TECHNICAL BULLETIN

LTB00487v6
09 JUN 2015

SECTION: 303-04D

3.0 TDV6 Excessive Exhaust Smoke

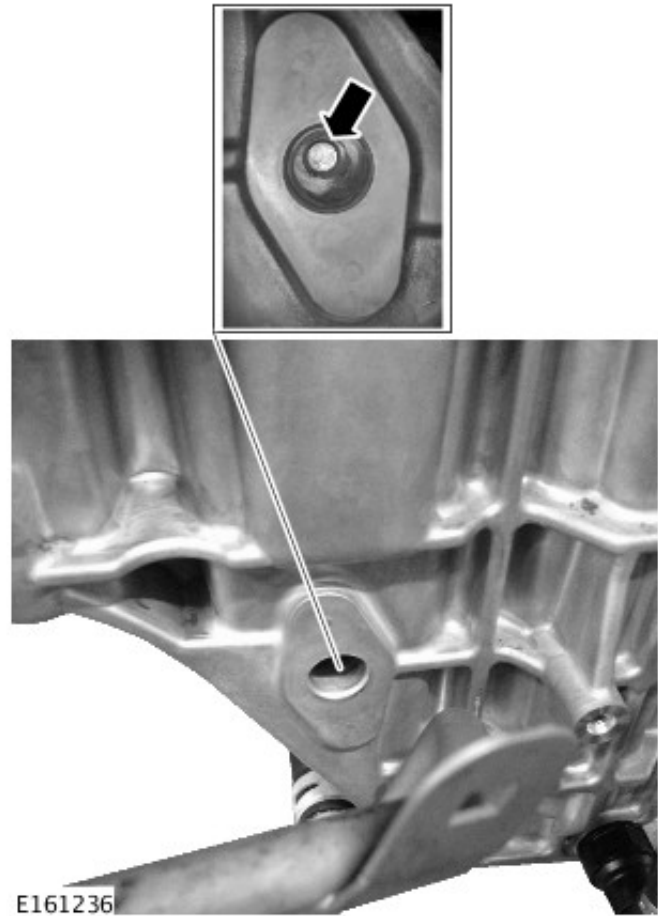
NOTE: On vehicles post the closing VIN range stated on this bulletin the sump has been cast over and the blanking plate not fitted. See attached pictures. This is effective from engine number 0753185.
